1. We have been requested by Queenstown Lakes District Council to peer review an updated plan for the internal road network for subdivision application RM200615. We undertook previous peer reviews on 29 January 2021 and 14 April 2022. Since the last peer review, the following changes have occurred:
 - The collector road (Road 1) will access the site at the southern-eastern corner, thus avoiding access along a significant part of Woolshed Road.
 - The collector road is realigned to pass through the centre of the site to a roundabout on the northern boundary as indicated below in **Figure 1**.

Attachment 1: Applicant's Plans Peer Reviewed

WOOLSHED ROAD DEVELOPMENT MASTER PLAN

ROAD 1
2 X 4.2m MOVEMENT # 2 X SEPARATE PARKING

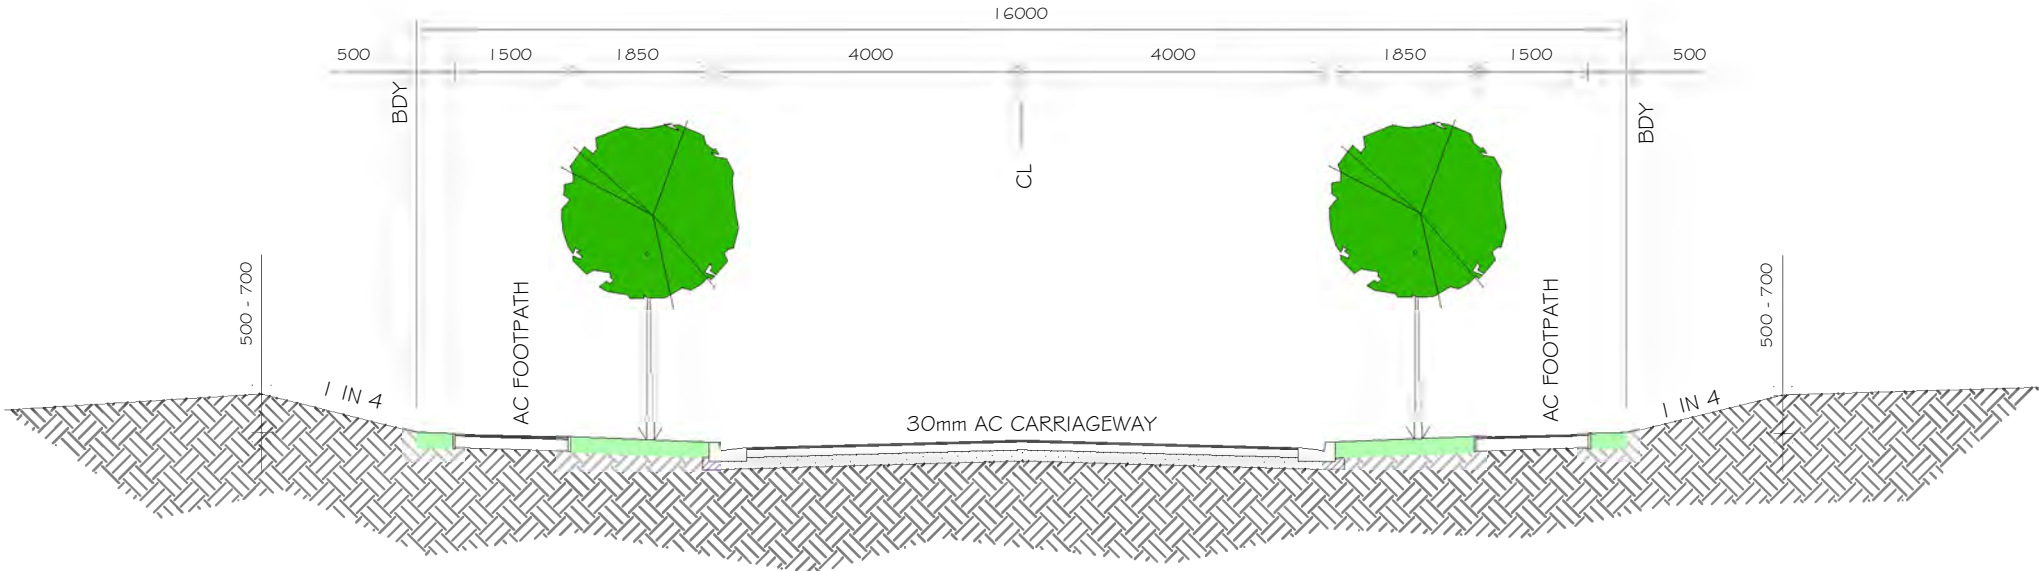
27. Note that if a shared path cross section of 2.5m is agreed, appropriate cross-sections will need to be added to the drawing set.
28. Various Lots (Lots 2001 – 2006) have been shown as recreation reserve on the layout plan. The location of three recreation reserve areas (Lots 20002 – 2004) in the centre of the plan with a footpath running through the middle, suggest a desire line of pedestrians. There is a pedestrian crossing at the western side of Lot 2002 but none at the eastern end of Lot 2004. To maintain connectivity and consistency, a pedestrian crossing point is recommended across Road 4, at the eastern side of Lot 2004.

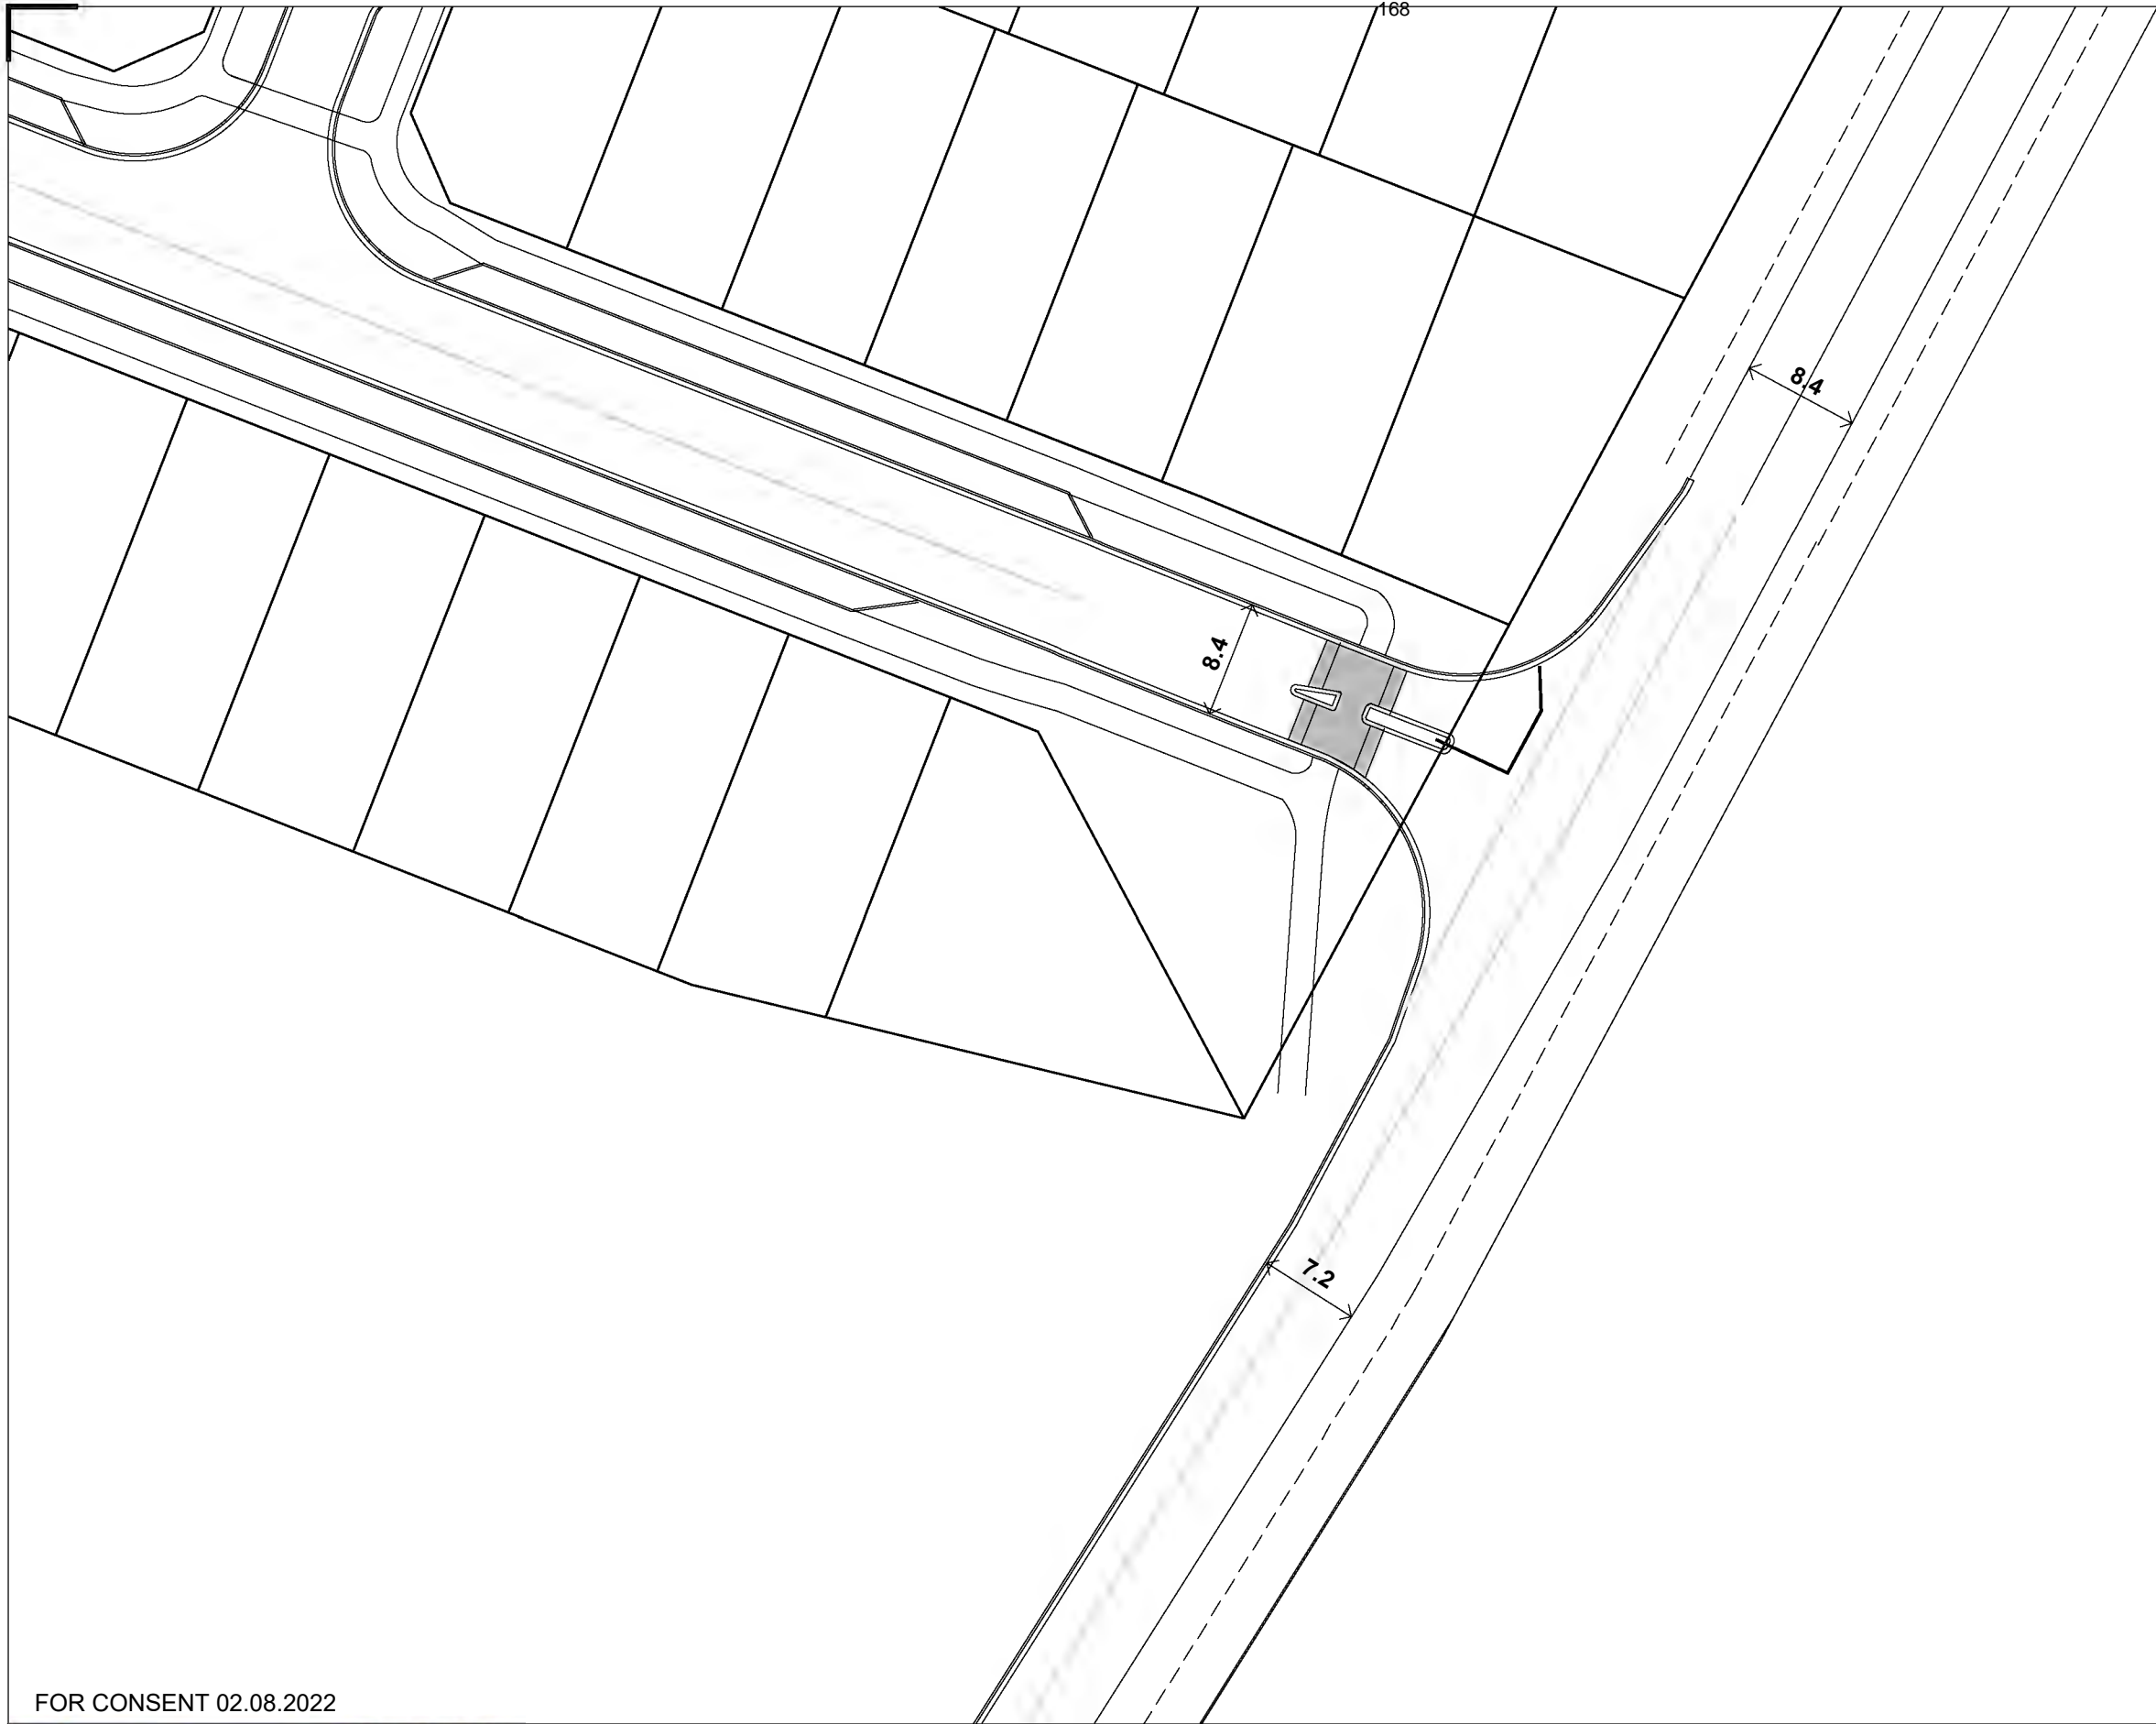
33. The proposed intersection (see sheet 10 in **Attachment 1**) consists of a priority intersection with no right turn lane from the major road, a potentially narrow refuge and a departure lane width that may only accommodate one vehicle at a time turning onto Woolshed Road.

35. It is recommended that if a right turn lane along Woolshed Road and/or additional departure lanes for traffic are not required, that land is made available for these improvements to be made in the future if required. Particularly, as other development is planned in the future. It is recommended that this is discussed and agreed with QLDC.

Please see attached the updated plans, specifically sheet 010.
